RE: Staff Review Comments for Conditional Use and Level II Site Plan Review

Project Name:	Etz Chaim Synagogue Addition	Project ID:	2012-556
Applicant:	Etz Chaim Synagogue	CBL:	21-E-19
Planner:	Nell Donaldson

TO: Nell Donaldson, Planner
FROM: David Senus, P.E. & Ashley Auger, E.I.T.
DATE: August 29, 2012
RE: 267 Congress Street, Final Level II Site Plan Application

SITE, GRADING & UTILITY PLAN
 OF
ETZ CHIAM SYNAGOGUE
 267 CONGRESS STREET
 PORTLAND, MAINE
 JOHN H. LEASURE ARCHITECT, INC.
 SIX & STREET
 SOUTH PORTLAND, ME 04106

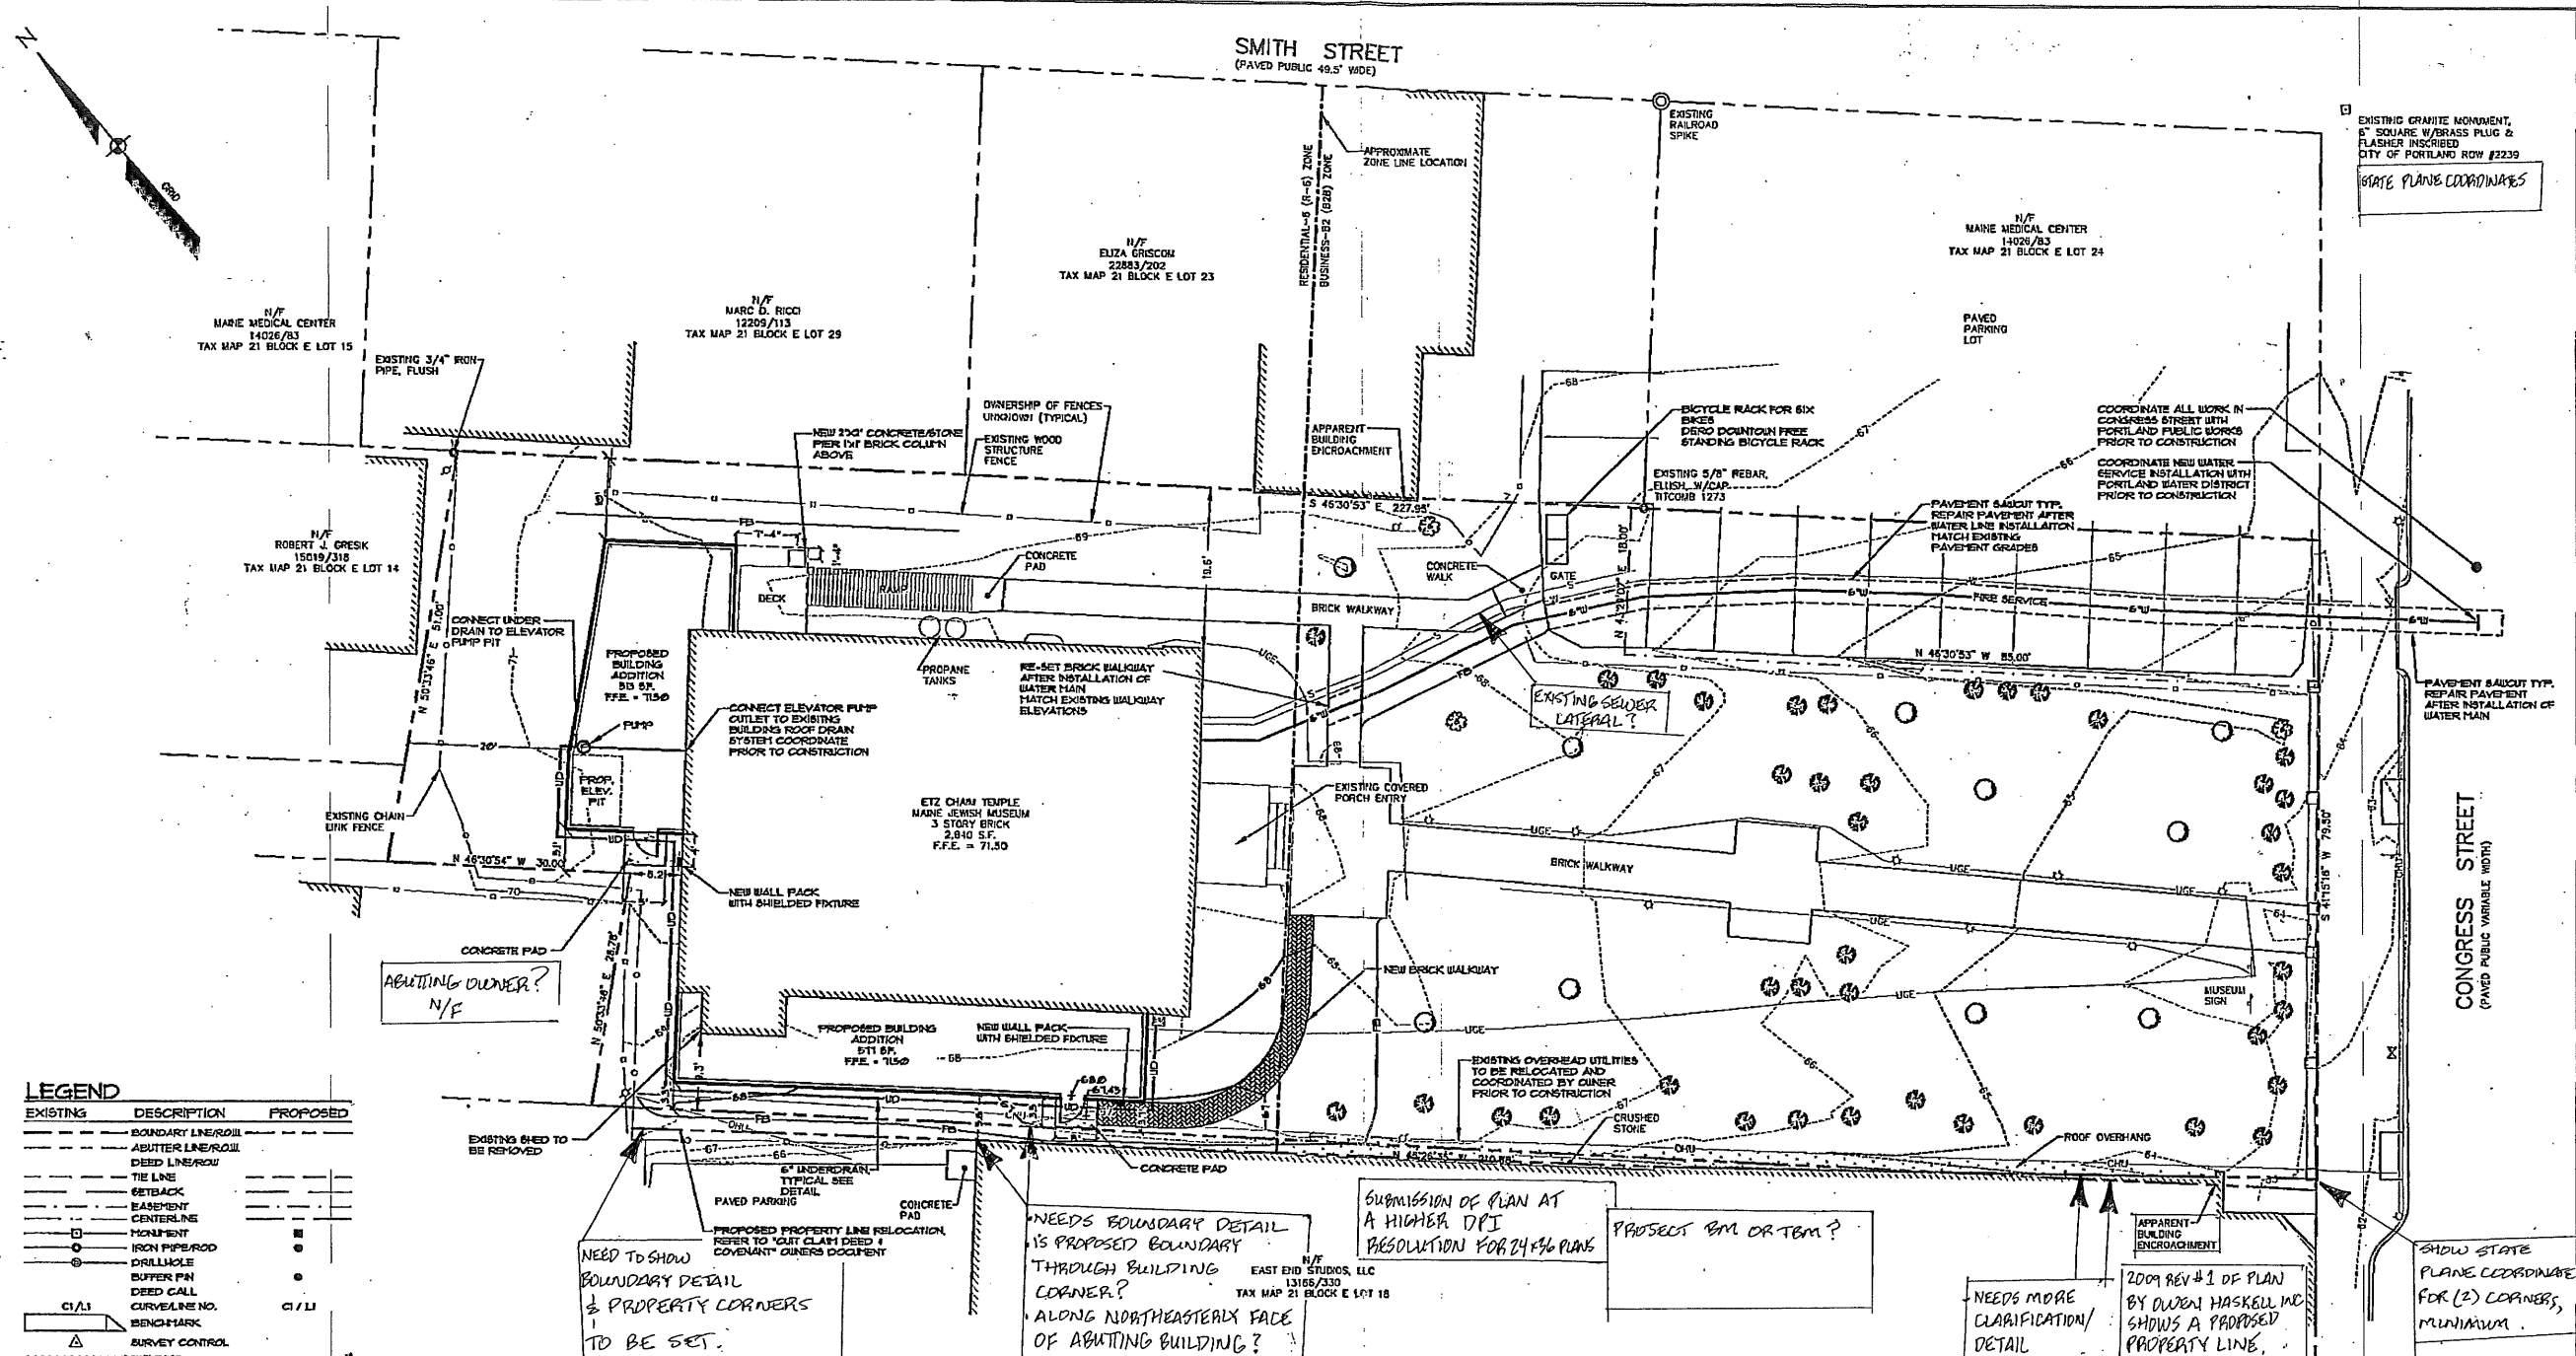
- 1) The applicant should provide a pavement repair detail for work within the City Right-of-Way.
- 2) The brick driveway repair detail should be updated to be in conformance with Figure I-11 of the City of Portland Technical Manual. The depth of base gravel should be 12".

1. The applicant should note on the plans that as a result of the proposed installation of the 6" water line, a 21" spruce tree will likely be removed.
2. There is an abandoned curb cut through which the applicant is proposing to install a new 6" water line. The applicant is requested to eliminate the abandoned curb cut after the 6" water line has been installed. The granite curbs should be taken to the City stockyard on outer Congress St. where at that location granite curbing can be found to fill in that cut.
Thank you.
